Nº 49 Rev. Technical Brief

SUBJ: Harley-Davidson™ Autotrol Motor 50Hz
Interface Kit & Installation Instructions

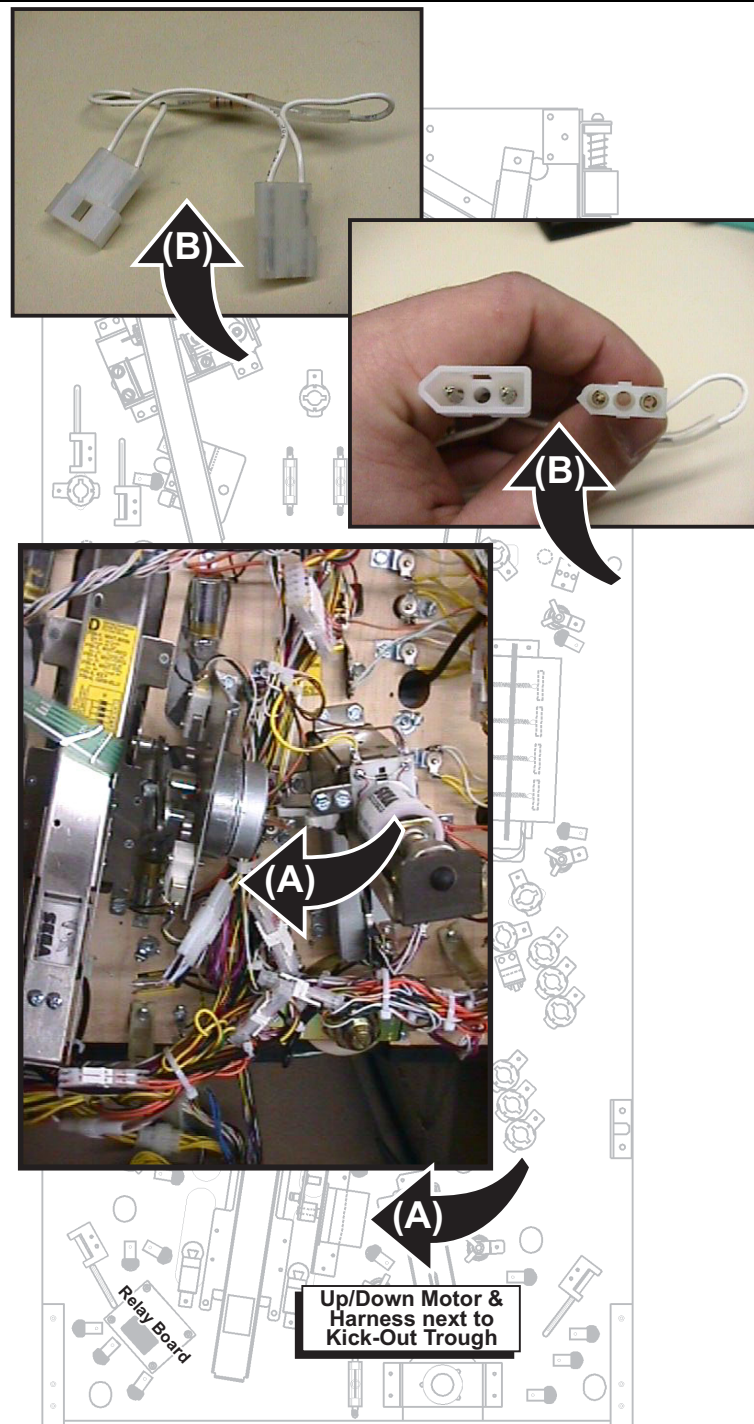
Intermittent operation or jogging of the
motorcycle up/down motor in countries
using a 50Hz Line Frequency.

We have observed in countries using a
50hz line frequency that some motors
stutter or operate intermittently. We have
made an adapter harness that plugs into
the existing game harness between the
motor connector and the game harness
connector. This Harness contains a
68Ω 2 Watt Resistor which corrects the
intermittent operation of the motor. Though
only a some games have exhibited these
symptoms, we feel it is important to install
this harness in all games to ensure this
potential problem does not occur later.

**Always ensure power is turned off
before servicing any game.** After
bringing the playfield into the upright
position, locate the motor & its Harness (A).

*Note the male & female ends of the new
Interface Harness (B) will snap into the
Motor Harness connectors (A).*
